VALUE ENGINEERING STUDY

Project # CSSTP-0007-00(692) PI No. 0007692

SR 92 from SR 120 to CR 473/Cedarcrest Road
Cobb/Paulding County, Georgia

31 January 2013

PROPOSAL NUMBER: R-1.0

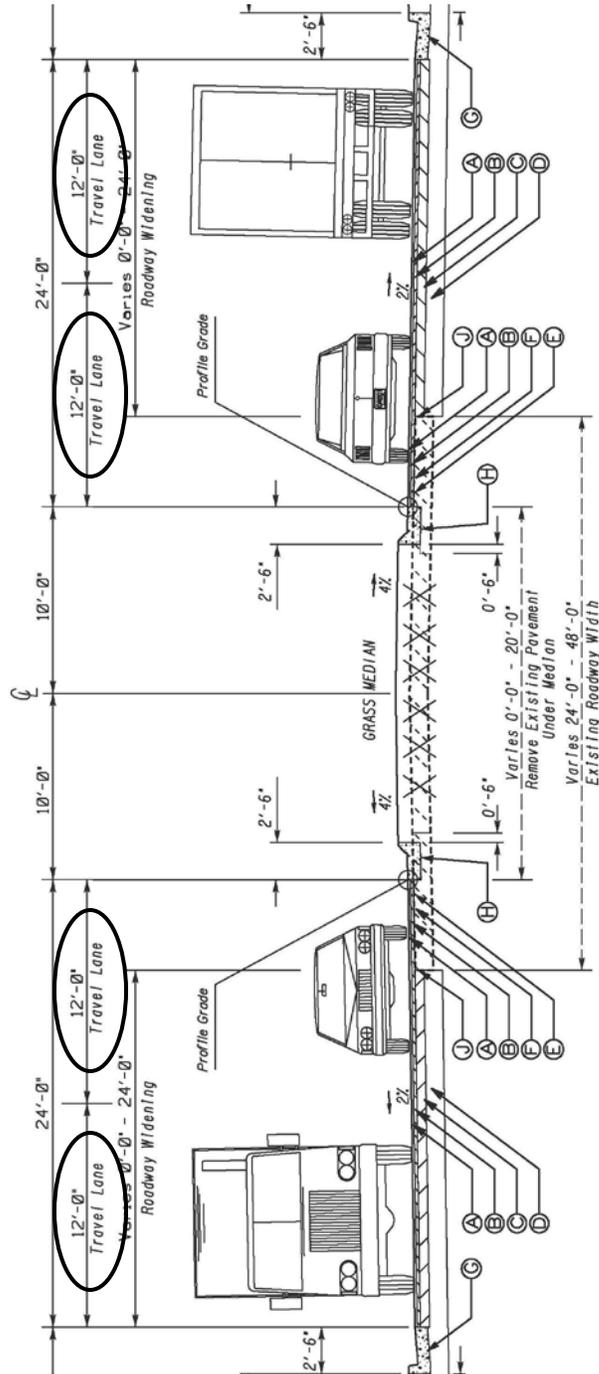
PROPOSED CHANGE: It is proposed to reduce all travel lanes on SR 92 from 12' to 11'.

Proposed Change: Revise 12'0" travel lanes to 11'0"

PROPOSAL NUMBER: R-1.1

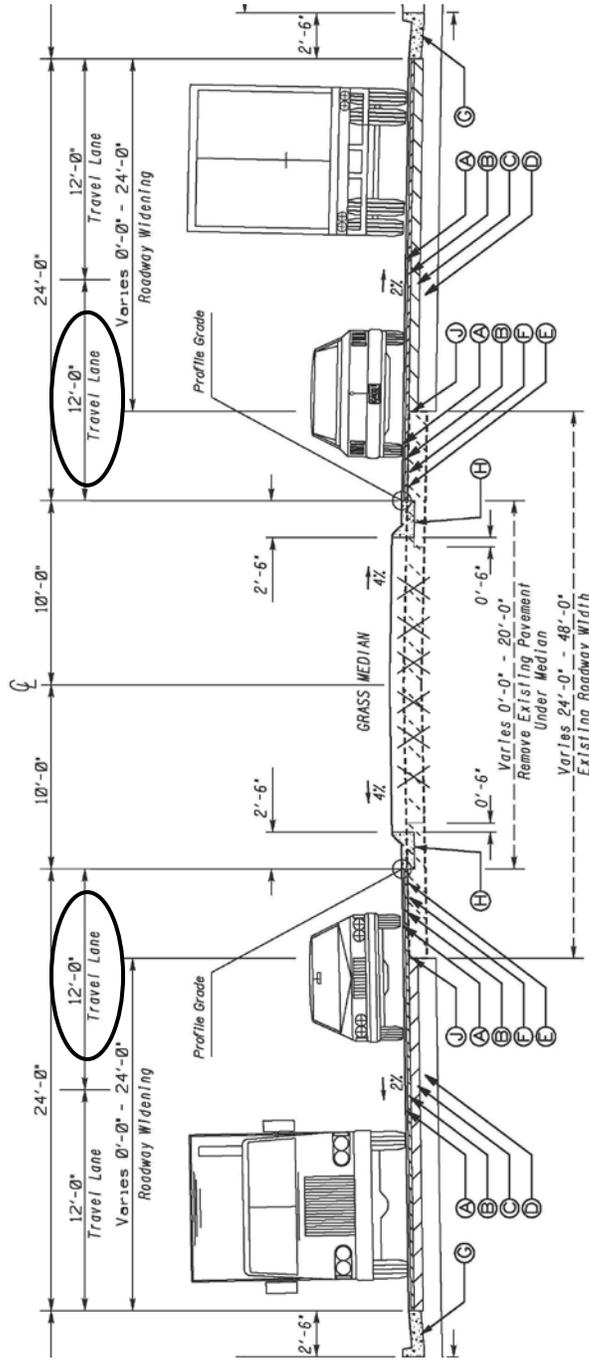
PROPOSED CHANGE: As an alternative to proposal R-1.0, it is proposed to reduce the inside travel lanes from 12' to 11' while maintaining the 12' width on the outside lanes.

Proposed Change: Reduce inside travel lanes from 12'0" to 11'0"

PROPOSAL NUMBER: R-2.0

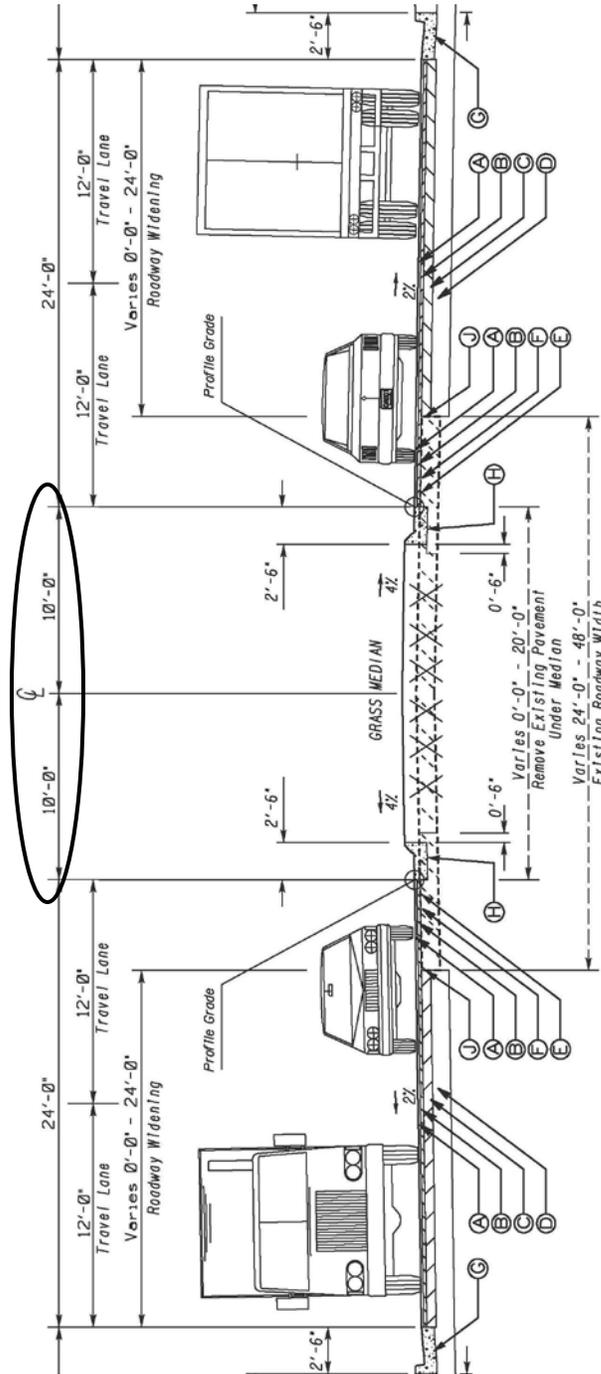
PROPOSED CHANGE: It is proposed to change the width of the raised median from 20 feet to 16 feet for this corridor.

JUSTIFICATION: A 16' raised median is being used on other GDOT projects (SR 9, PI #121690-) and AASHTO Chapter 7 (2011) allows a median width of 16' for Arterial roadways. Median with turn lane will be 4' per GDOT Detail A2. This does, however, require a design variance from GDOT.

Proposed Change: Reduce 20'0" median to 16'0"

PROPOSAL NUMBER: R-3.0

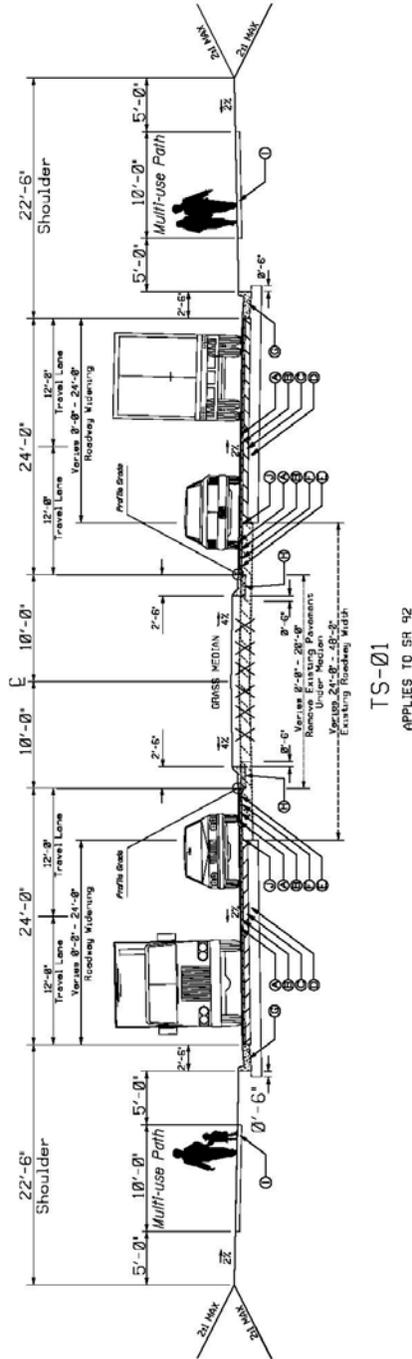
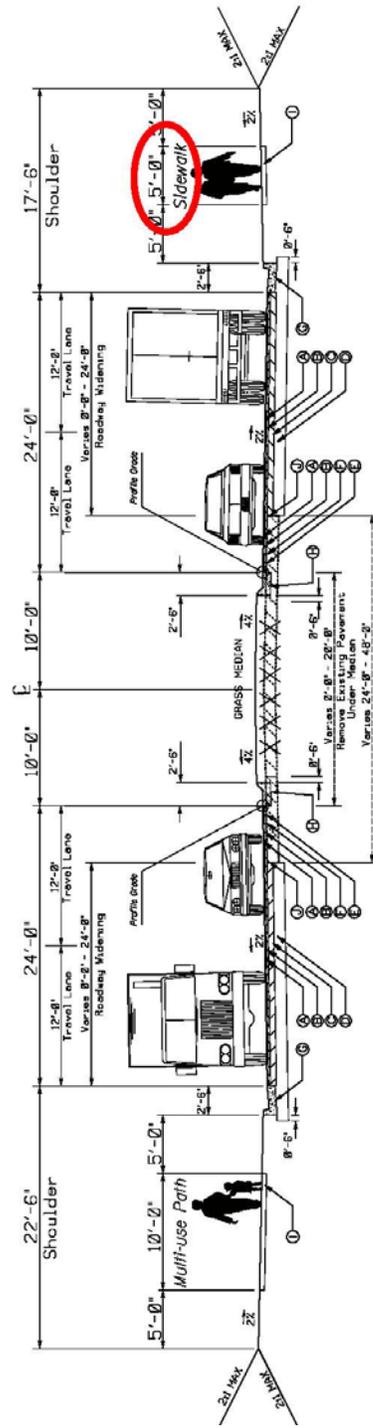
PROPOSED CHANGE: It is proposed to include a 10-foot wide multi-use trail on the West side of SR 92 and a 5-foot sidewalk on the East side.

JUSTIFICATION: The Paulding County Trails and Greenways Master Plan recommends SR 92 as a multimodal corridor and suggests accommodating bicycles and pedestrians. Since the majority of the subdivisions and the majority of the destinations (high school, middle school, and Picket’s Mill Battlefield Park) are located on the West side of the road it is likely more users would be present on the West side of the roadway. Pedestrian access would be provided by the 5-foot sidewalk and cross access would be provided at the roundabouts and signalized intersection.

Proposed Change: Use 10 foot trail on West side of Road and 5 foot Sidewalk on East side of Road

PROPOSAL NUMBER: R-3.1

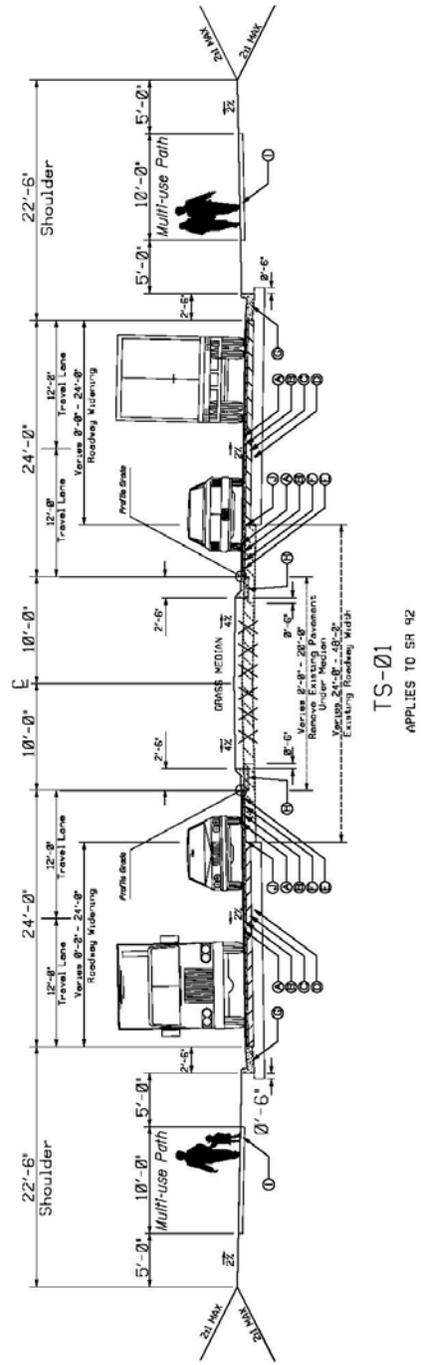
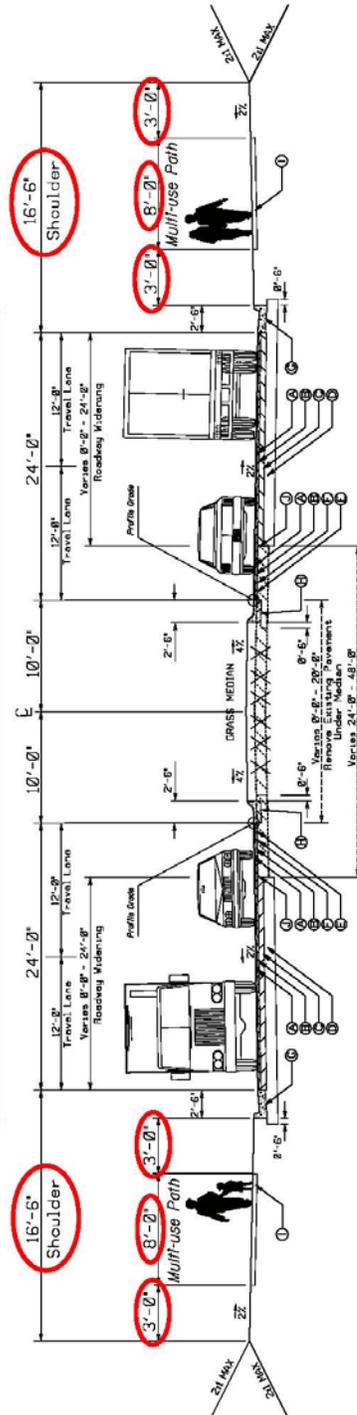
PROPOSED CHANGE: It is proposed to include an 8-foot multi-use trail on both sides of the roadway. Also, reduce the grass strips in front and behind trail from 5-foot to 3-foot width.

Proposed Change: Use 8 Foot Multi-use Trail on each side of Roadway;
Reduce 5 Foot Grassed Shoulder area to 3 Foot Grassed Shoulder

PROPOSAL NUMBER: R-3.2

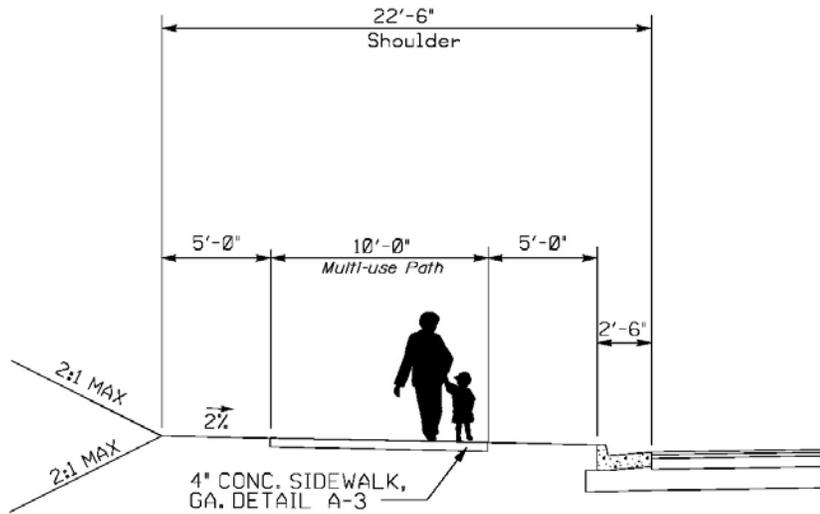
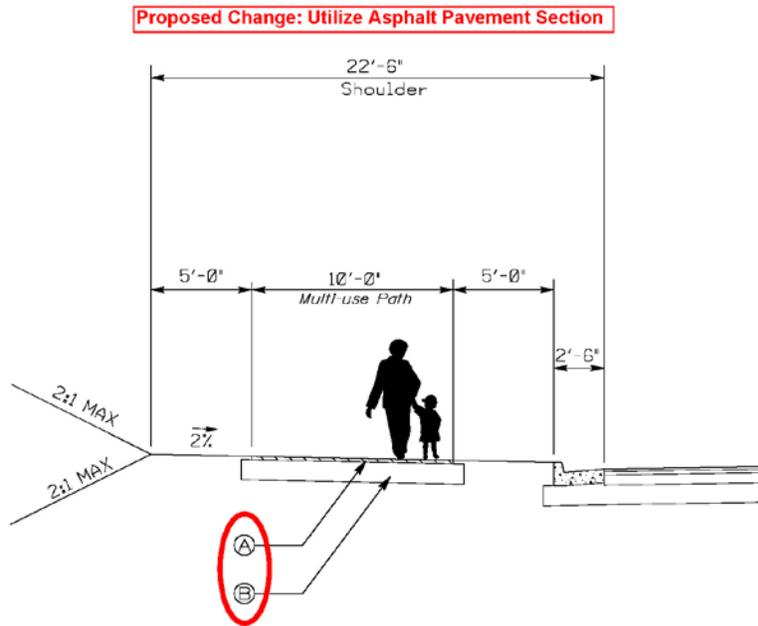
PROPOSED CHANGE: It is proposed to utilize an asphalt concrete pavement section for the 10-foot multi-use trail on both sides of the roadway.

PROPOSAL NUMBER: R-5.1

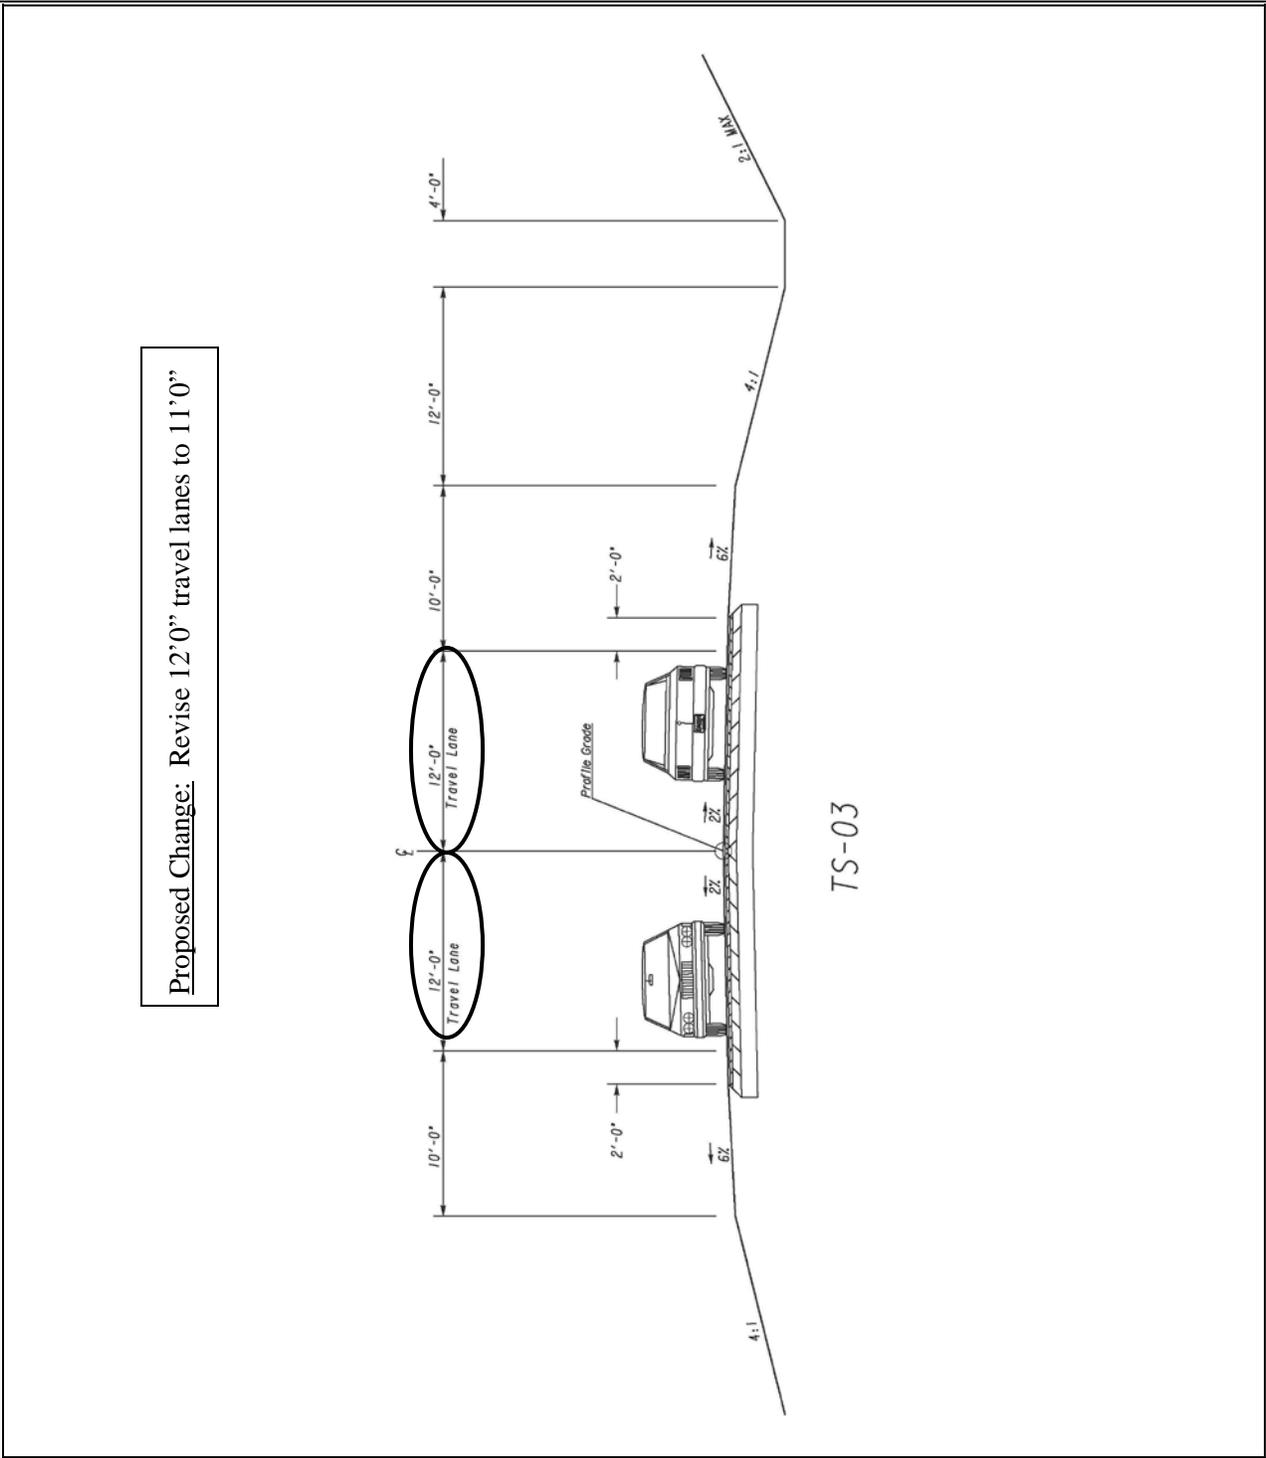
PROPOSED CHANGE: It is proposed to reduce all travel lanes on the Antioch Road Spur from 12' wide to 11'.

JUSTIFICATION: GDOT design policy allows 11' lanes for local roads as indicated in Table 6.4 of the Design Policy Manual. This revision will provide acceptable road widths for local roads and result in a cost savings to the project.

PROPOSAL NUMBER: R-5.2

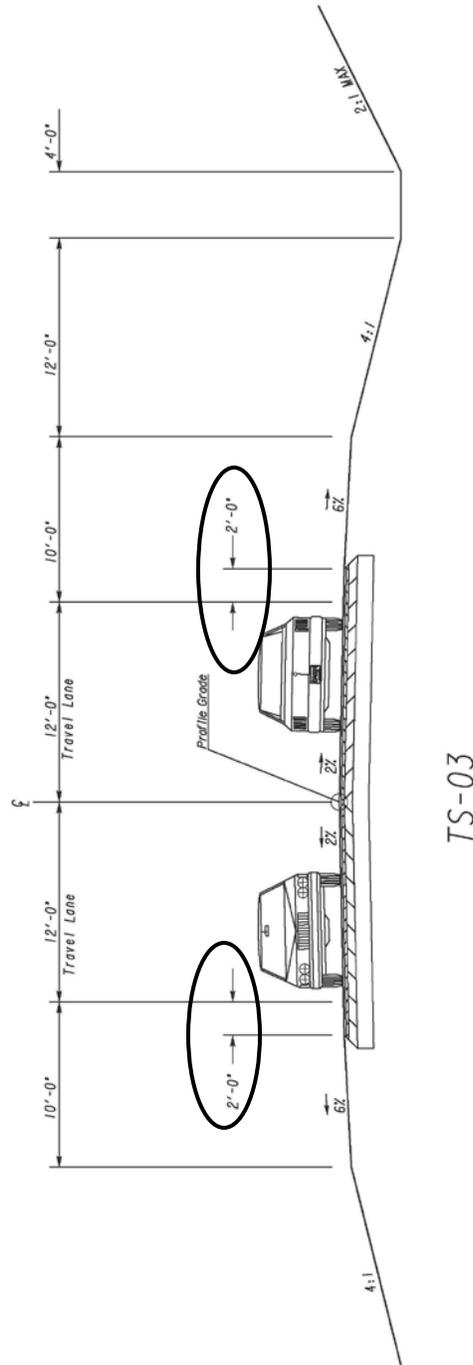
PROPOSED CHANGE: It is proposed to eliminate the paved shoulders on this new local road.

Proposed Change: Eliminate 2'-0" Paved Shoulders

R-6.0 – Proposed Change 1 of 1

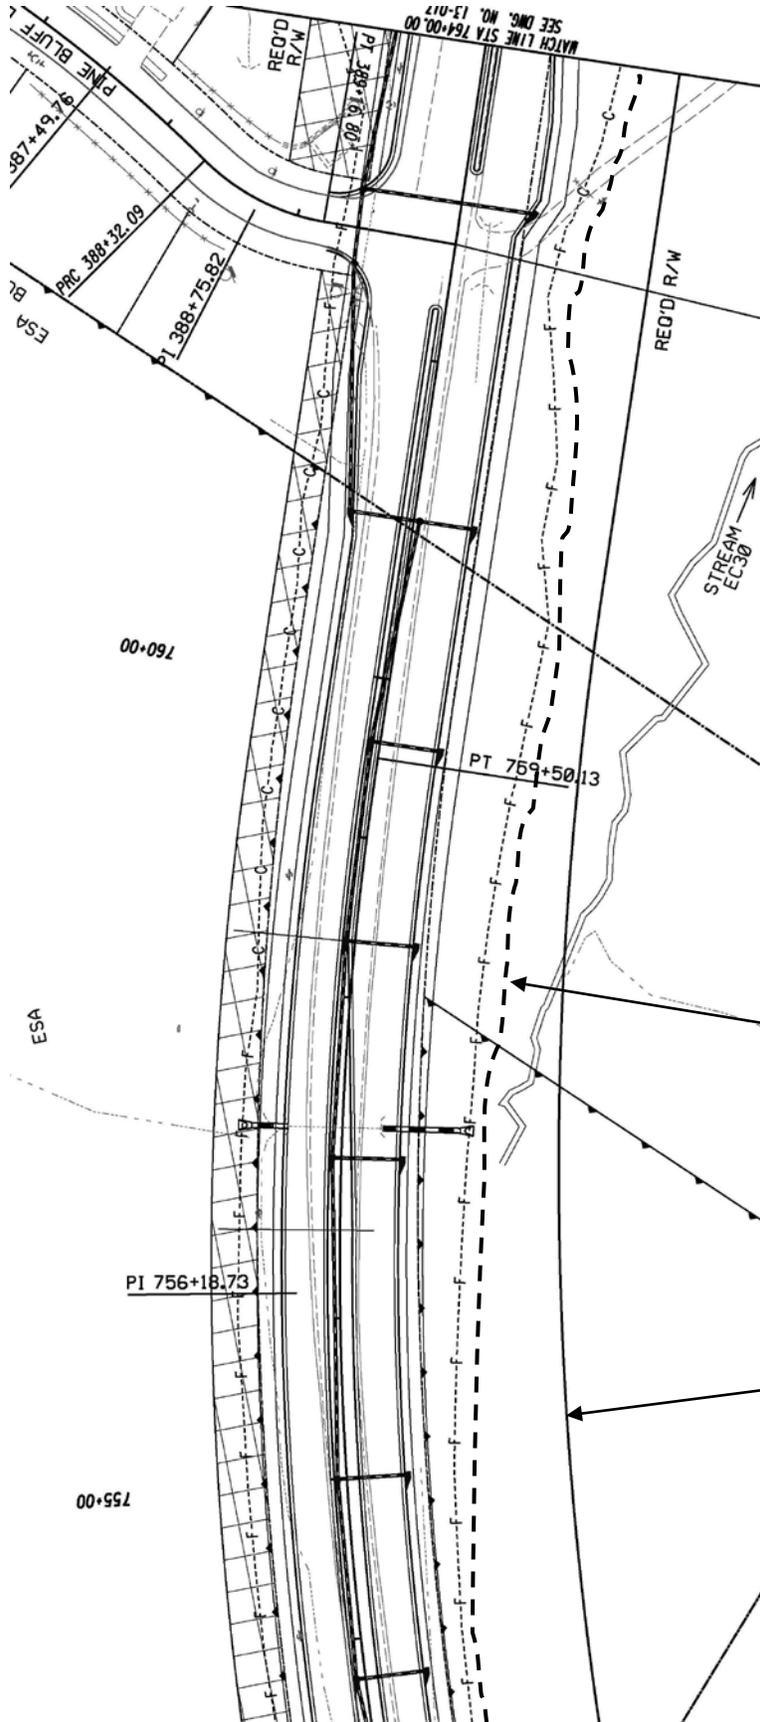
PROPOSED CHANGE: It is proposed to reduce the right of way corridor to an area that is no more than 10' beyond the construction limits of the project in lieu of a wide corridor.

Proposed Right-of-Way
(±10' Beyond Fill Line)

Current Right-of-Way
